Notice of Application for a Planning Permit

The land affected by the application is located at:	L4B LP6442 V4968 F530 42 Payne Road, Beaconsfield VIC 3807
The application is for a permit to:	Construction of a Replacement Dwelling, Construction, Use and Illumination of a Private Tennis Court and Removal of Vegetation

The applicant for the permit is:	West Gippsland Planning Services
Application number:	T240471

I refer to Councils Request for Further Information dated 29 October 2024.
In response to this request, attached below please find our response.

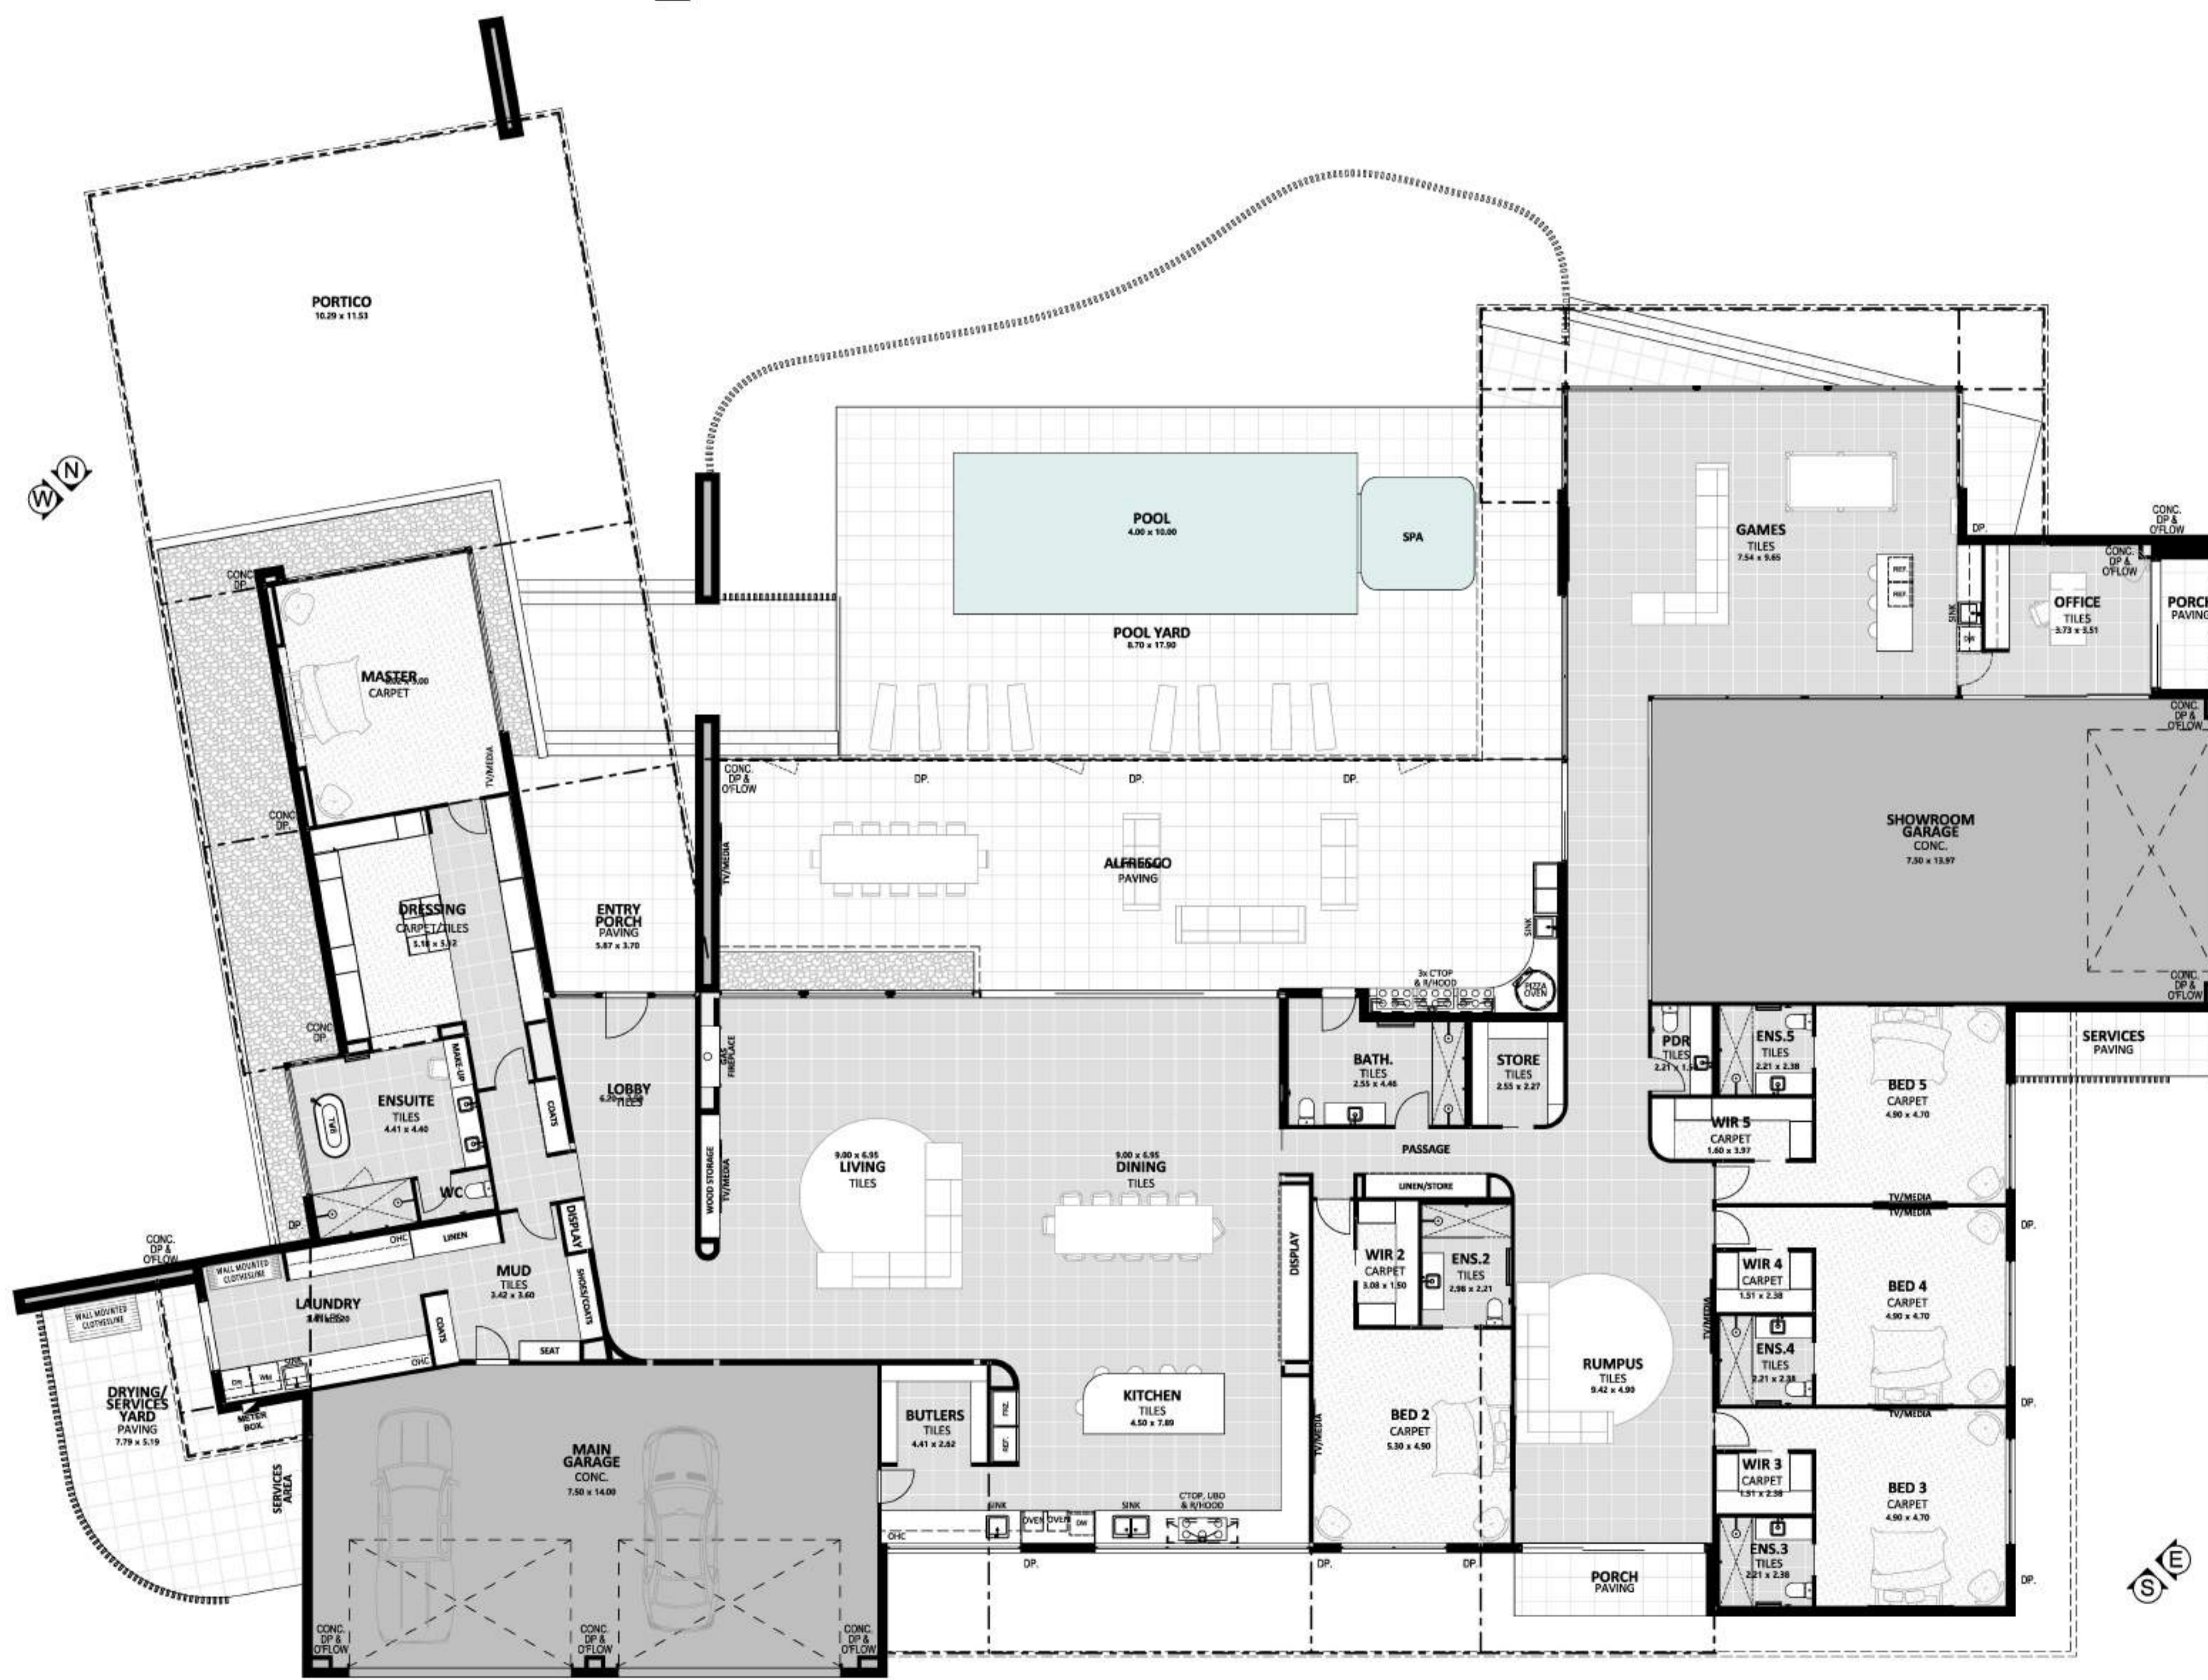
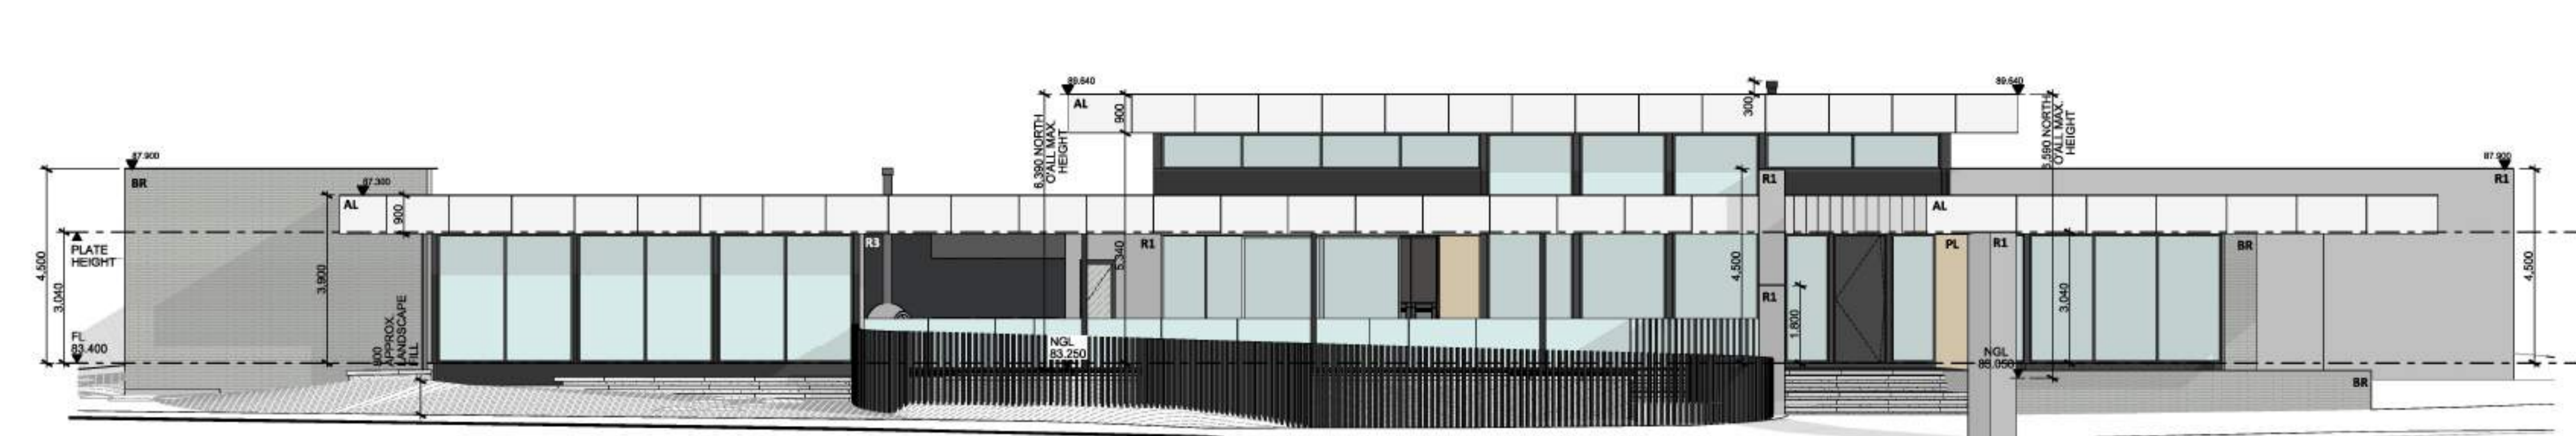
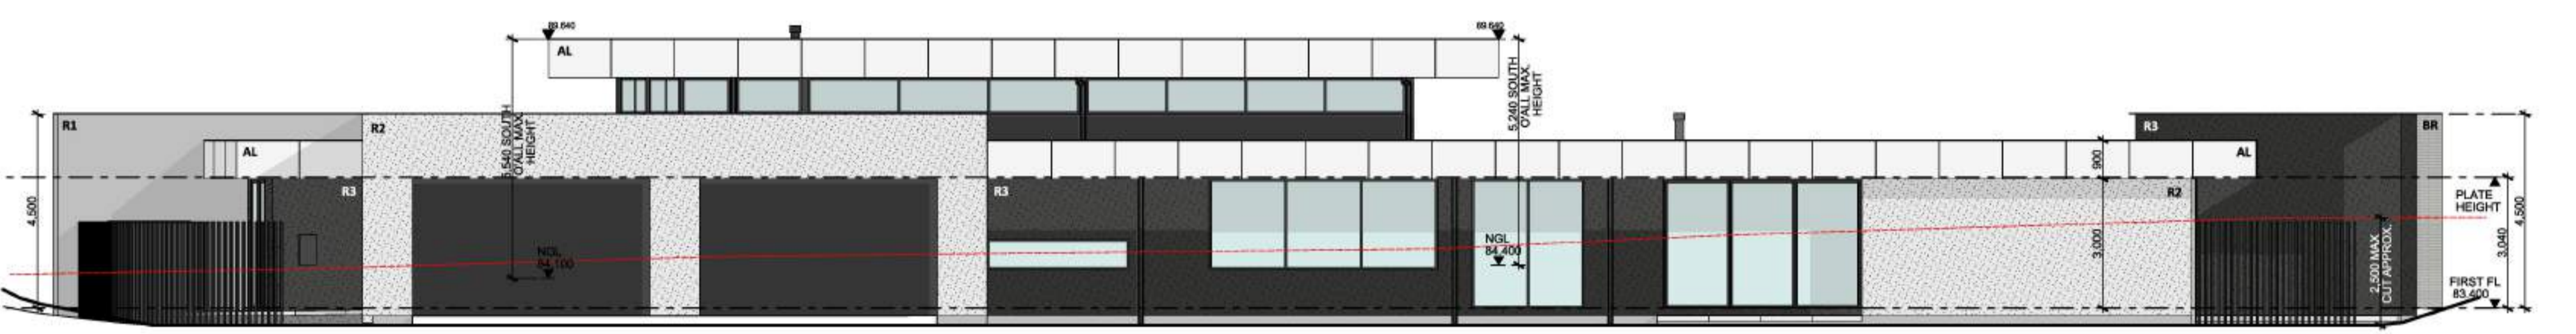
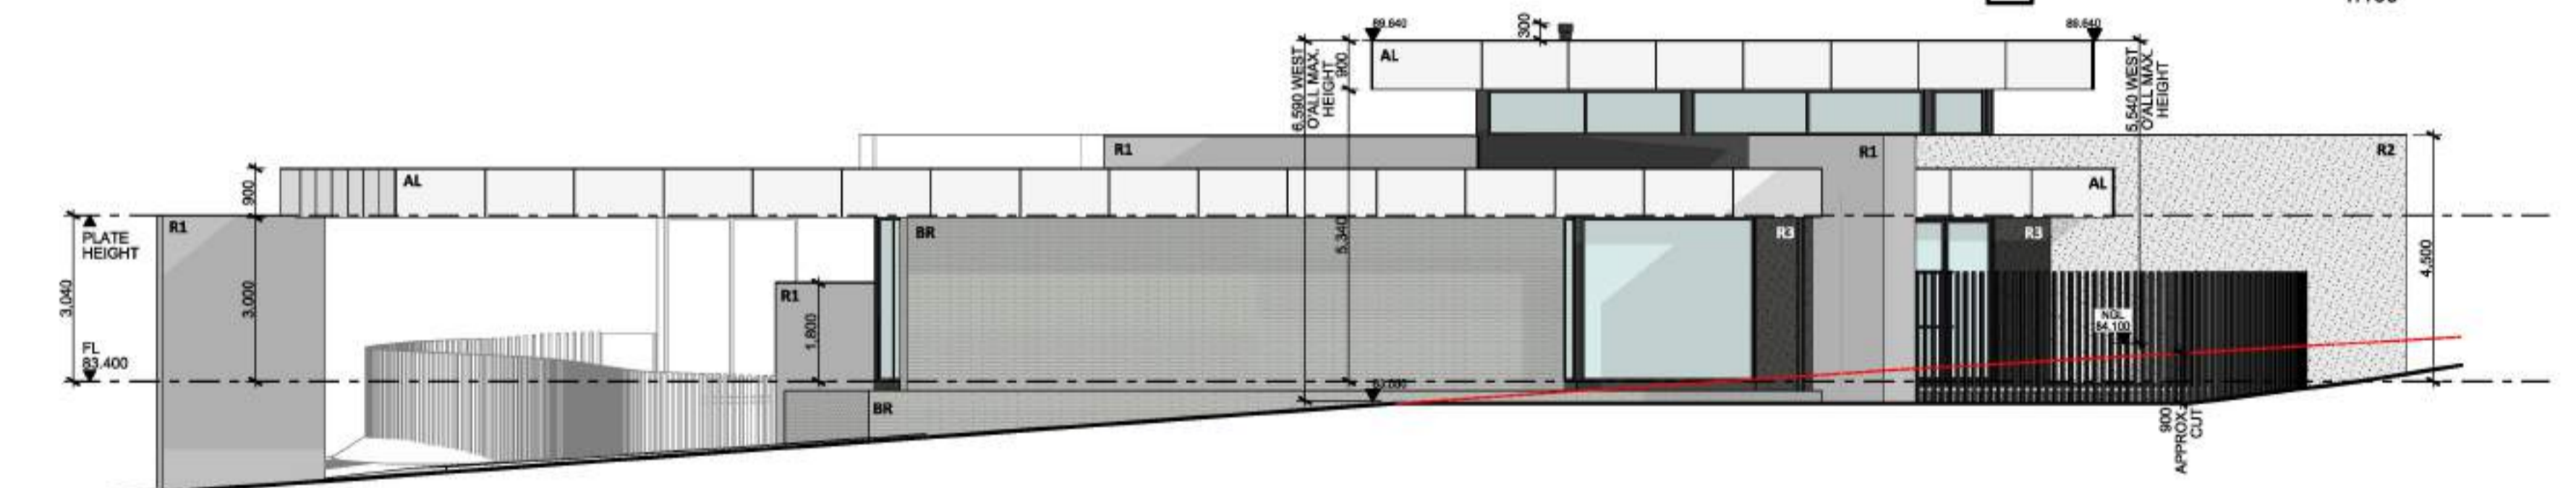
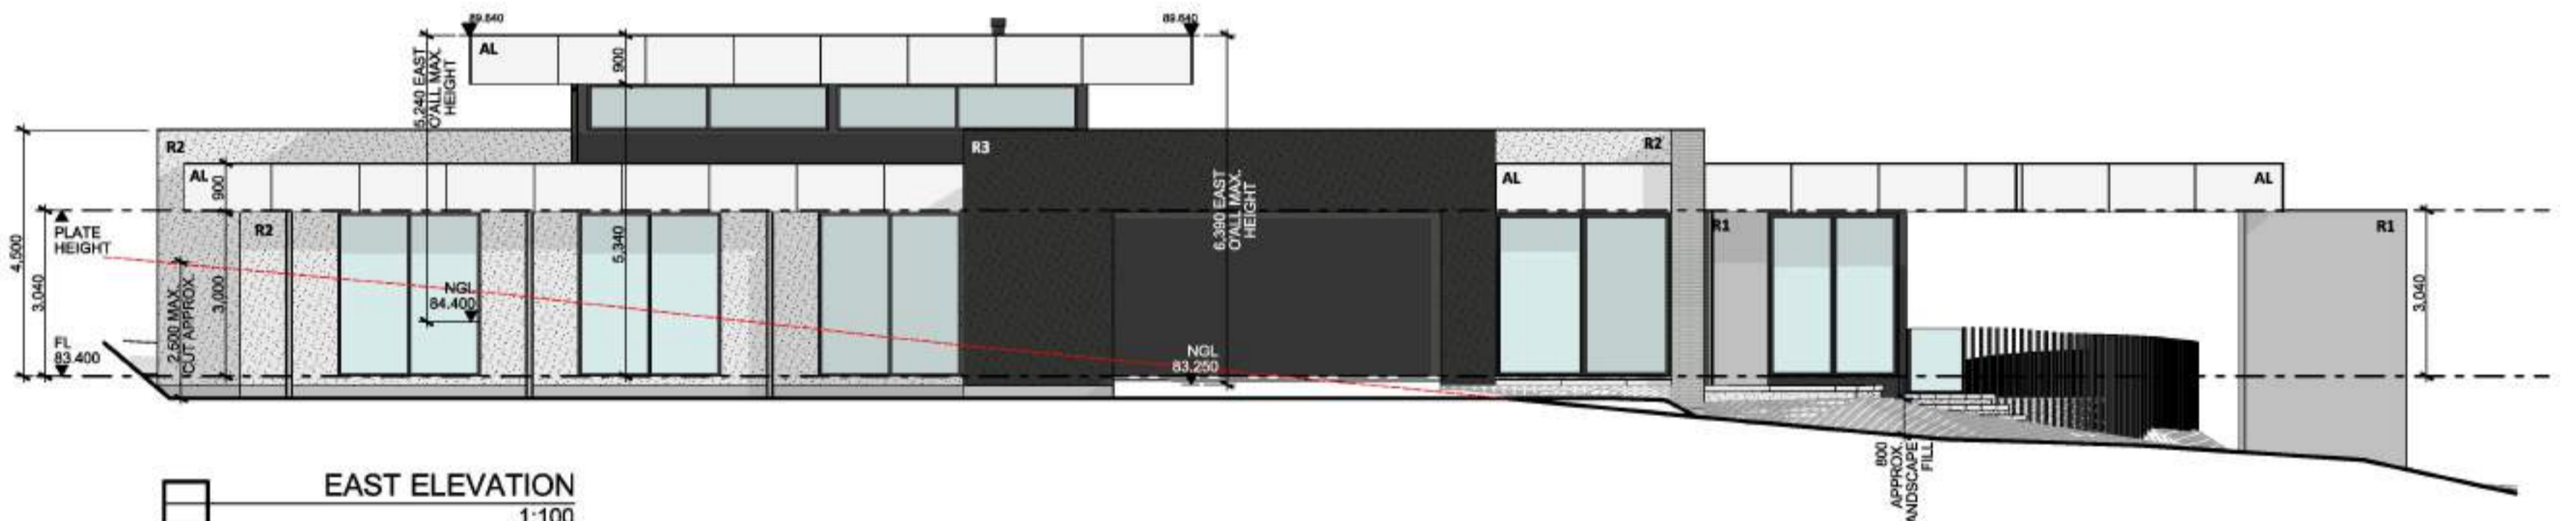
- Consider additional site cut to the south of the dwelling to recess the dwelling – The amended plans now incorporate the proposed dwelling further sunken into the land by approximately 2.50m to minimise the overall height of the dwelling.
